SUBJECT: February 5, 2026 HISTORIC PRESERVATION COMMISSION SPECIAL MEETING

Certificate of Appropriateness

815 West Beverley Street

Install Screen for Side Porch

815 W. BEVERLEY ST EXISTING PORCH
NORTH ELEVATION TO BE SCREENED
NOT VISIBLE FROM STREET

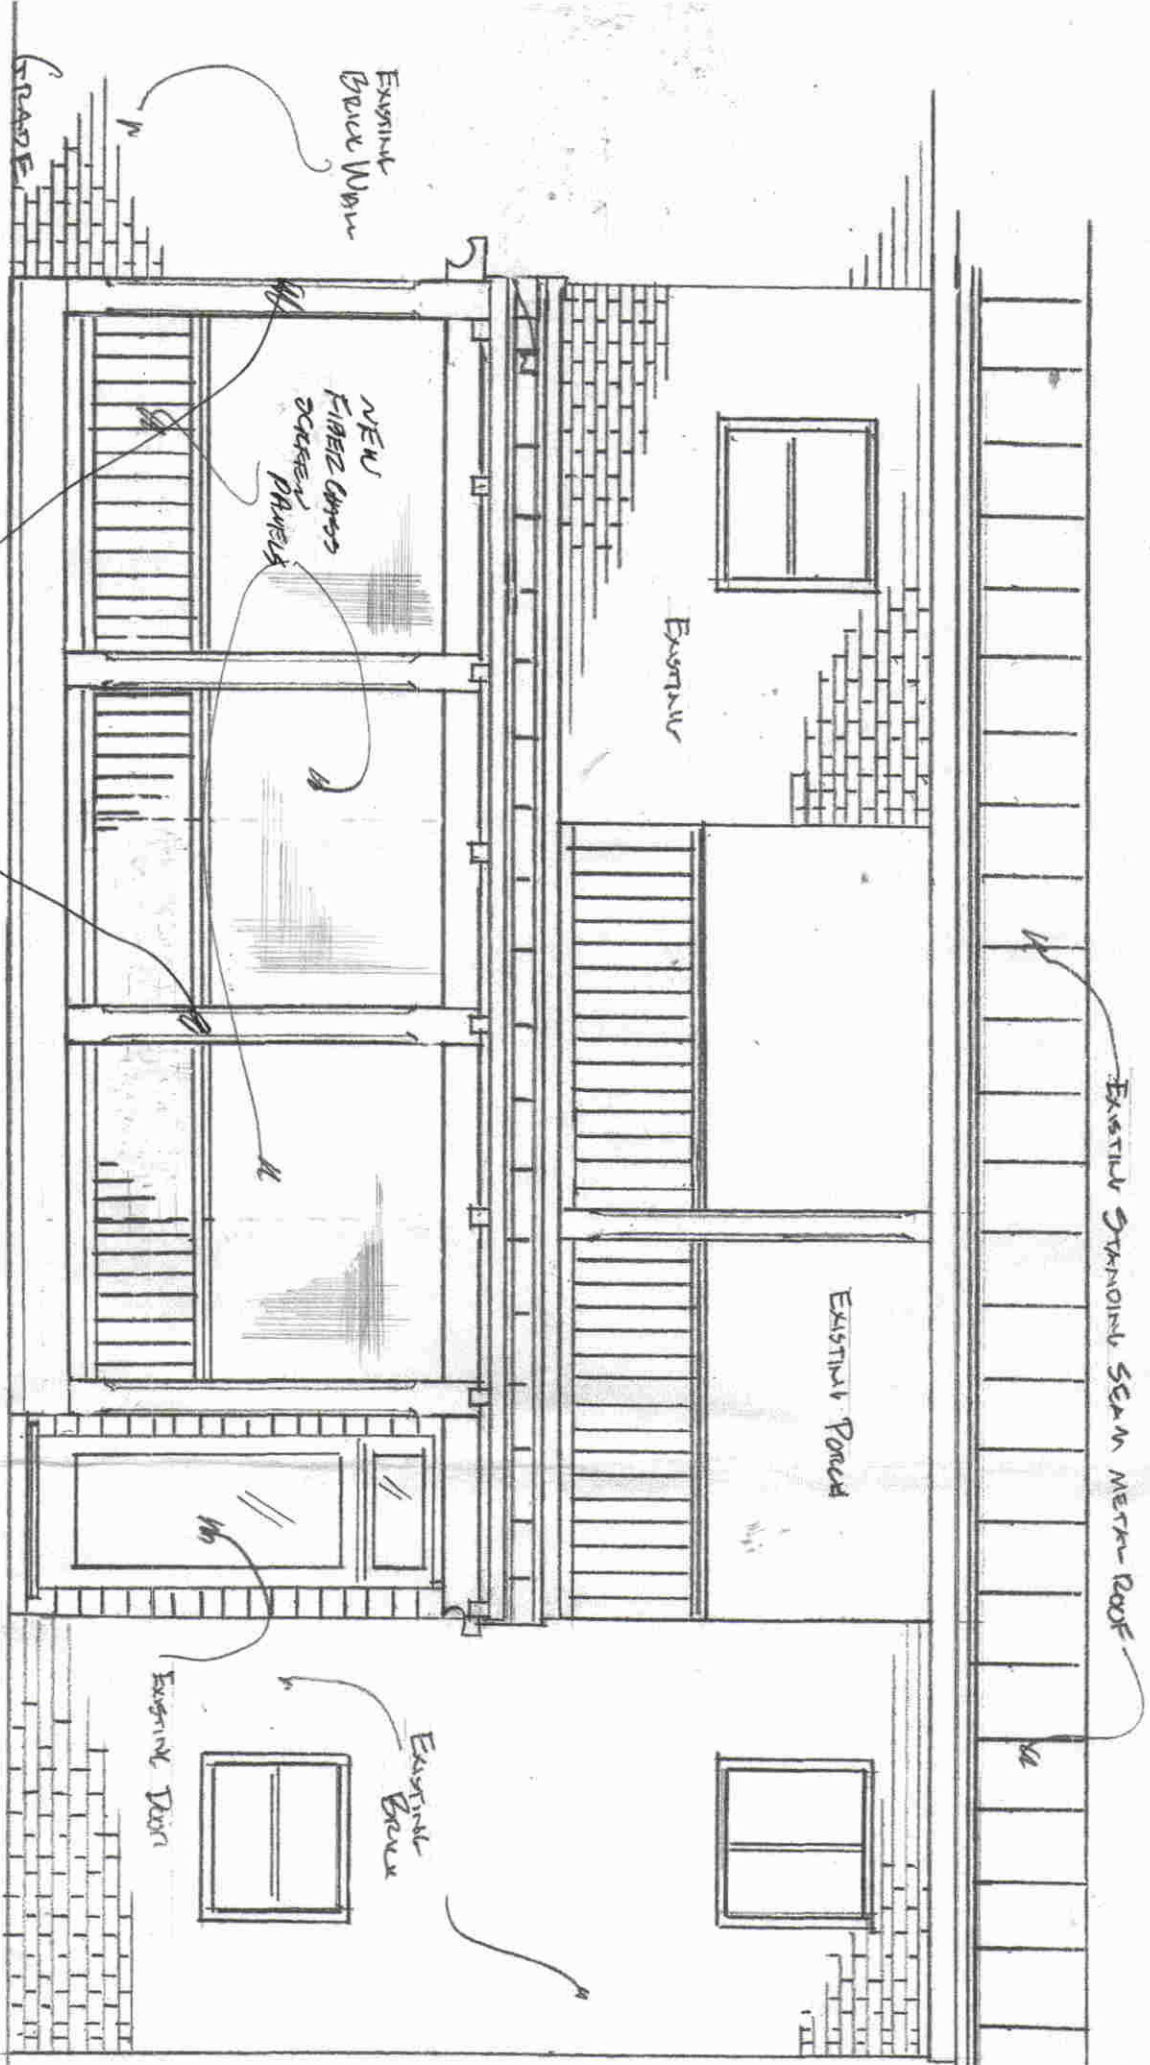
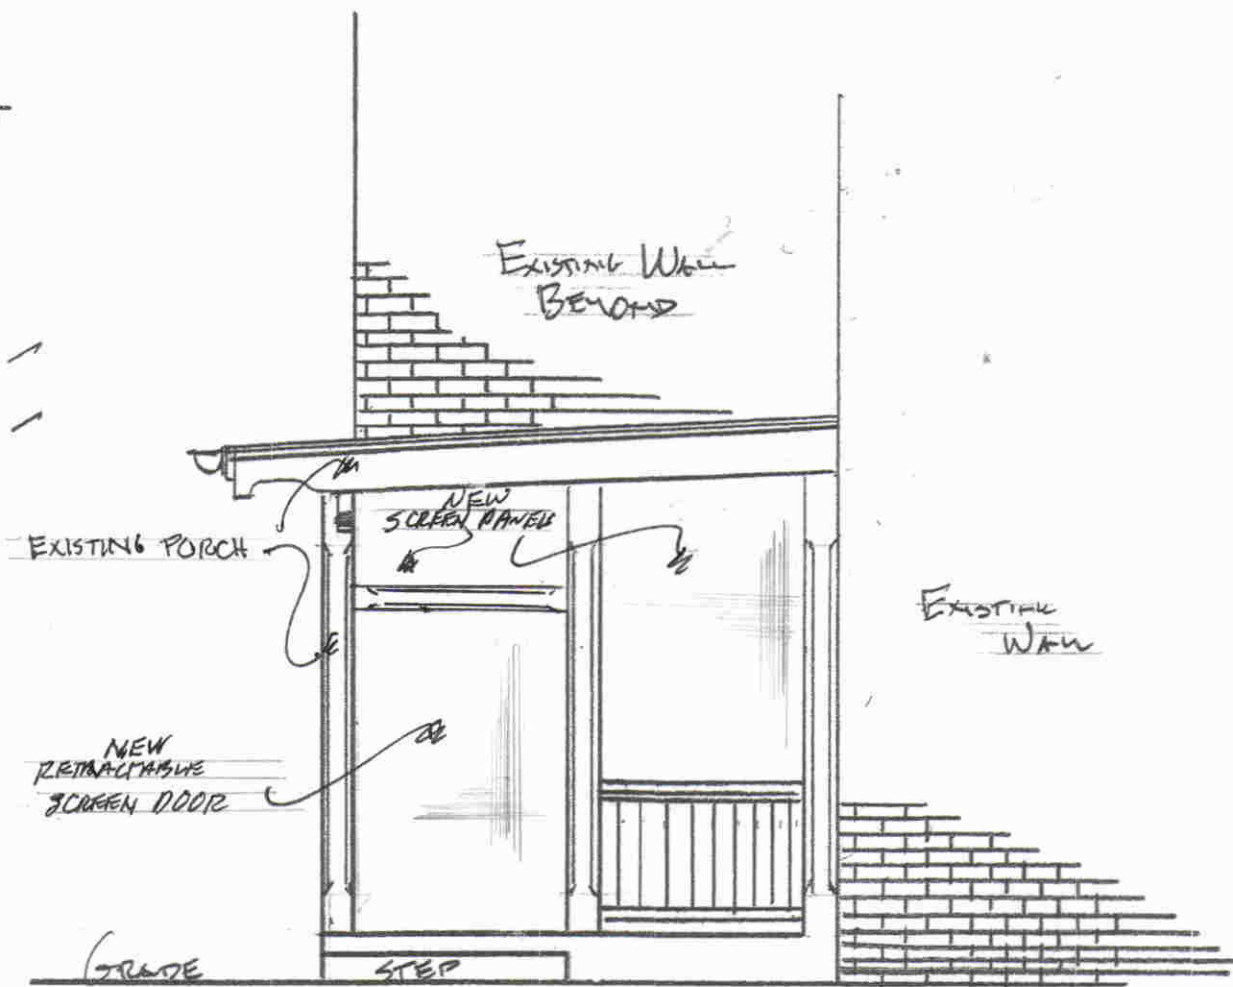
HSF Recommendation: HSF recommends the certificate of appropriateness be approved. The porch is located at the side and toward the rear of the house with limited view. The treatment does not enclose the porch and will not alter the size, scale, or materials of the porch.

Sample Motion: I move the Certificate of Appropriateness be appropriateness be approved as submitted.
